# PREVOST

## WARRANTY BULLETIN

### WB14-39

DATE :	SEPTEMBER 2014	SECTION :	22 - HVAC
EXPIRATION:	SEPTEMBER 2016		
SUBJECT :	POWER CABLE INSPECTION AND DECAL ADDITION

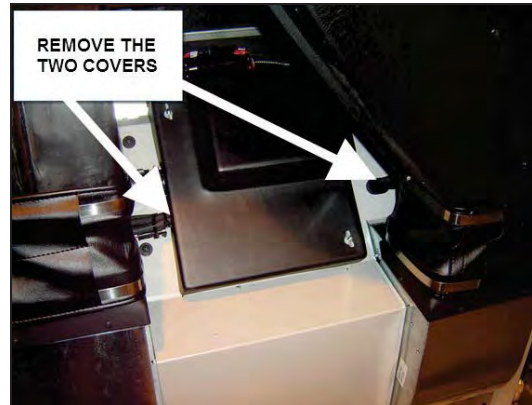
2. Inspect the power cable at location shown in picture.

- Cut the cable tie on top of fan housing to create some play on the cable. Adjust to give proper clearance.

- Clean cover with alcohol. Let dry.
- Place label #069158 inside control box cover in this location. (arrow)
- Re-assemble covers.
